**Sub-Committee of Experts on the
Transport of Dangerous Goods**

**Report of the informal correspondence group on burning
rate: Amendments to subsection 51.4 of the Manual of Tests
and Criteria**

**Transmitted by the expert from China on behalf of the informal
correspondence group**

1. This document contains the text of section 51 of the Manual of Tests and Criteria with the amendments proposed by the informal correspondence group listed in document ST/SG/AC.10/C.3/2024/94 – ST/SG/AC.10/C.3/2024/15.
2. All changes are indicated: deleted text appears in ~~strikethrough~~ and new text in **bold underlined**.

Figure 51.4.1: Measurement of radiation as a function of time

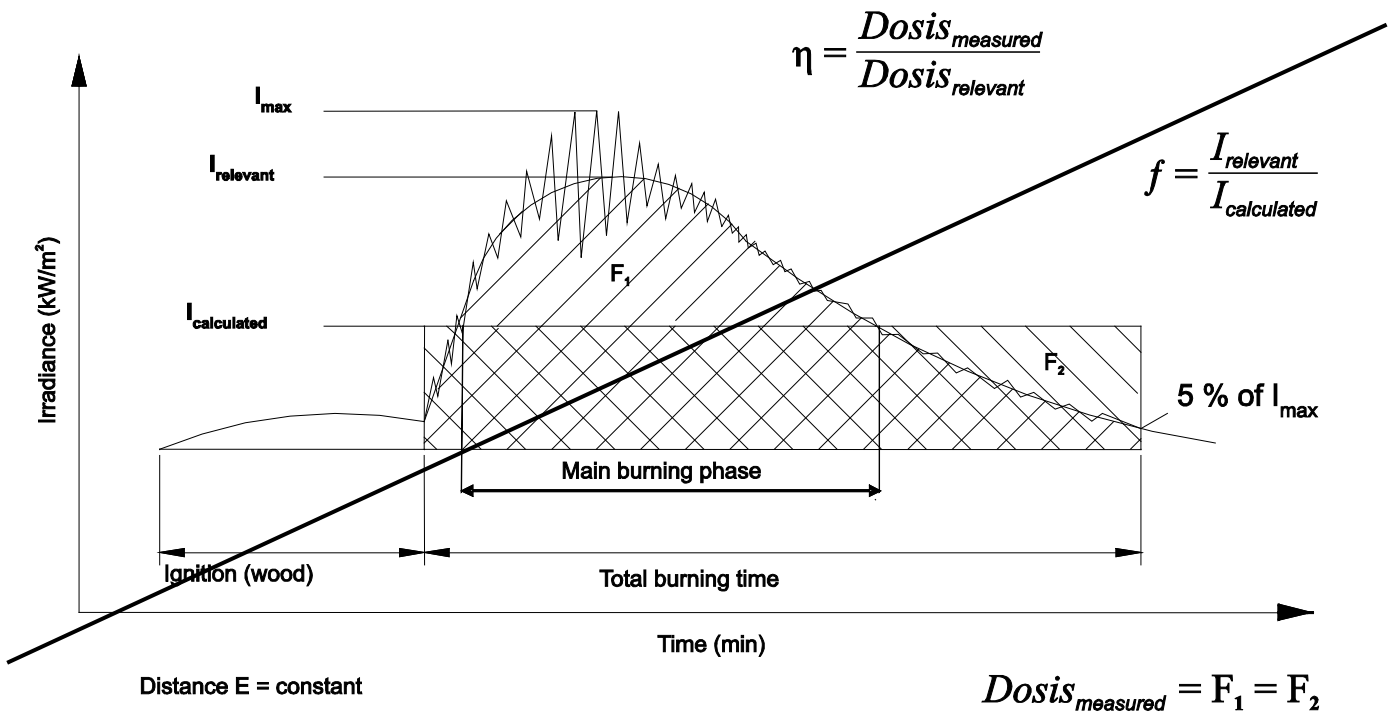
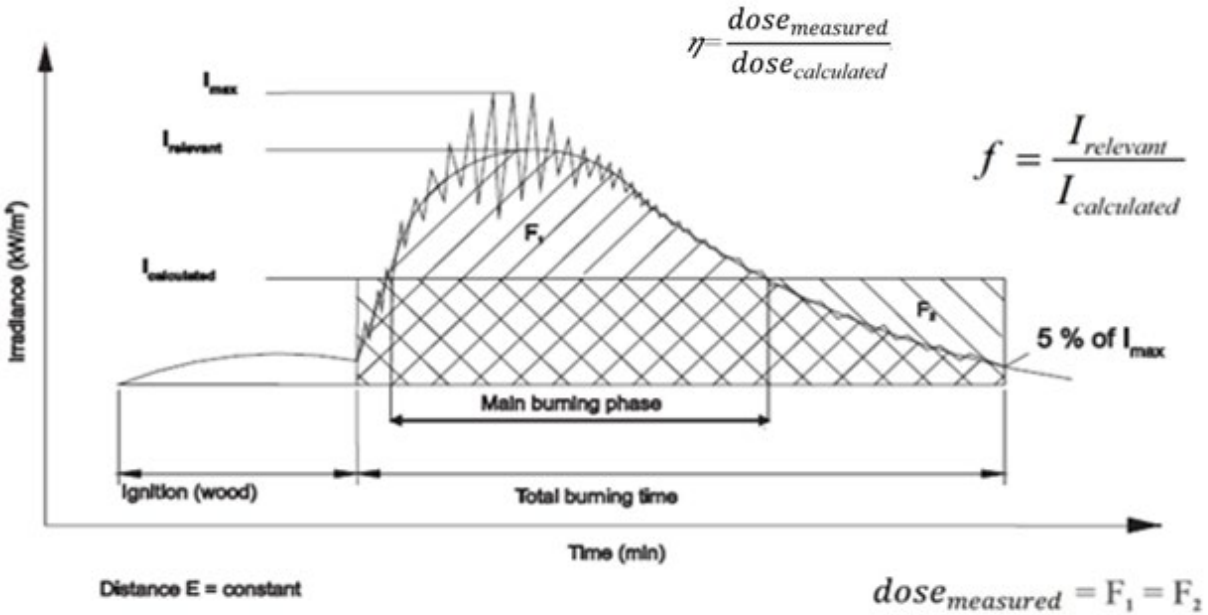
- (a) The starting point of the fire is defined as the moment at which the substance or mixture reacts detectably. The end **point** of the fire is characterized by a decrease in **irradiance radiation level-I** (as caused by the fire) to less than 5 % of the maximum **level-irradiance (I_{max})**. **The total burning time t is the time span between the starting point and the end point of the fire** (see figure 51.4.1);
- (b) The effect of either remainder or burning materials, if present, shall be taken into account in the evaluation;
- ~~(c) The burning time t is the time span between the starting point and the end of the fire;~~

- (d) To this end a graph is made showing the ~~radiation level~~ **irradiance** I [kW/m²] as a function of time. The complete radiation dose is calculated by integration of the smoothed and corrected curve down to 1% to 5% of I_{max} ;
- (e) $I_{relevant}$ is obtained from the maximum of the **smoothed and corrected** curve of **the measured** heat radiation. ~~$I_{calculated}$ calculated is the~~ as average value of the radiation **obtained** by converting the integrated area in a rectangle of equal size during the same **total burning** time span (see figure 51.4.1);
- (f) The form factor f that must be taken into account during the maximum fire intensity can be averaged from the formula:
